This drawing has been reviewed and found
in general conformance with the contract documents.
APPROVED ☑
APPROVED AS NOTED ☐
REVISE AND RESUBMIT ☐
RWR 4/11/03
KCI CONSTRUCTION CO. DATE
SPEC. SECTION BRIDGE A-4

MoDOT Job #J6I1581
KCI Submittal #014
Per Job Special Provisions
Section A-4

PROJECT: I-70 BEAUTIFICATION
LOCATION: ST. LOUIS, MO
ARCHITECT: HNTB
CONTRACTOR: KCI CONSTRUCTION

HT ELEVATION

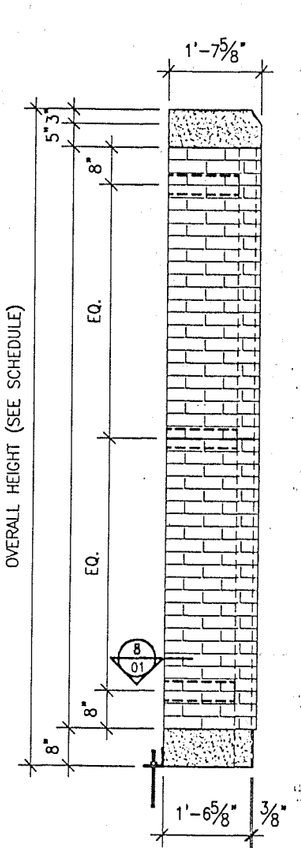
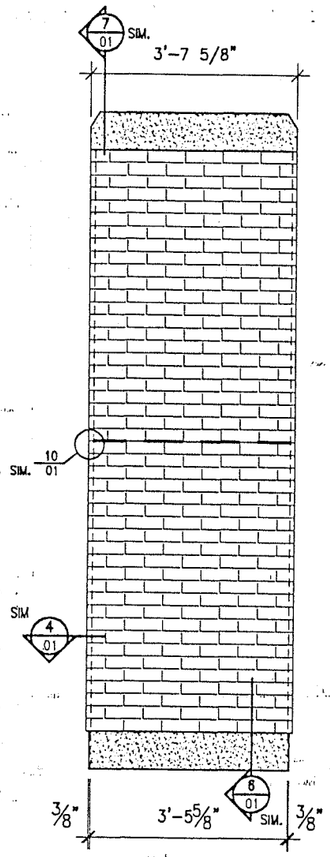
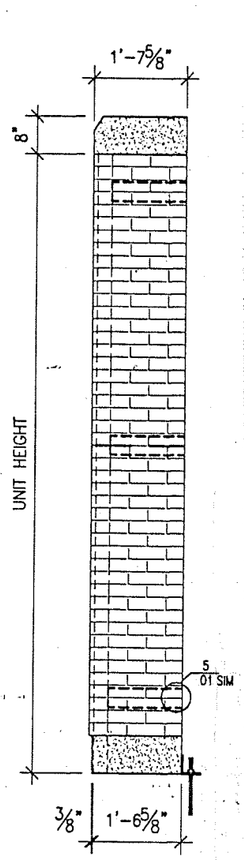
Arch/Eng-Height for
Union waiting for ans
RFI #10.

:h/Eng-Height for columns at on waiting for answer to KCI RFI #10.

UNIT PLAN
AT 2'-6" COLUMN

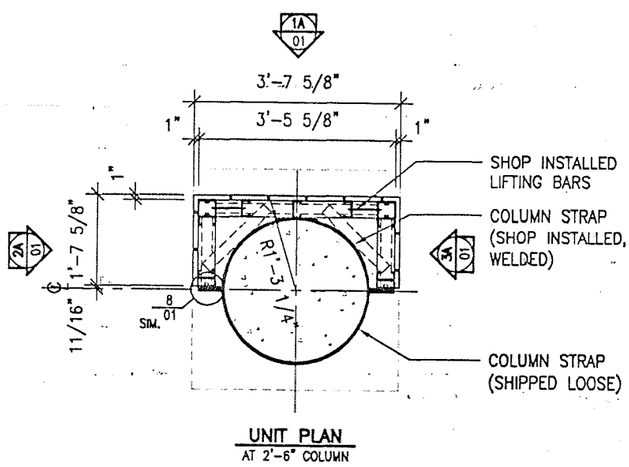
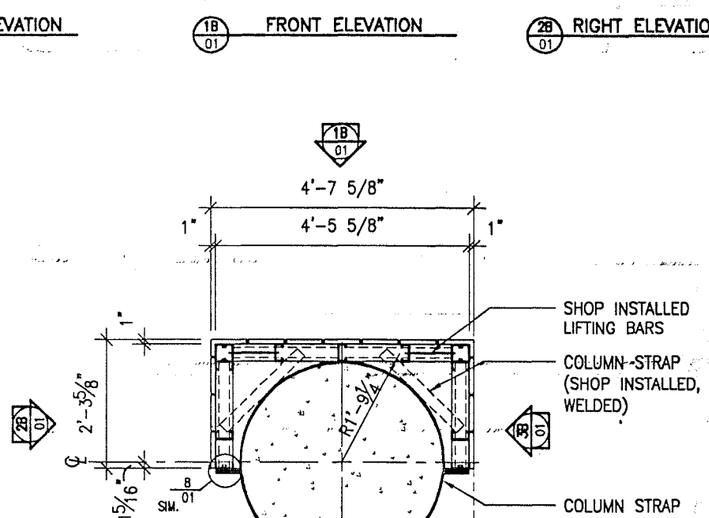
Architect/Engineer Note:
the panels for the 2'-6"
changed to reduce the num
done to per previous disc
prior project with th
acknowledge

ect/Engineer Note: The overall dimensions of panels for the 2'-6" and 3'-6" columns were l to reduce the number of cut bricks. This was to per previous discussions with HNTB on a ior project with the same panels. Please acknowledge if acceptable.
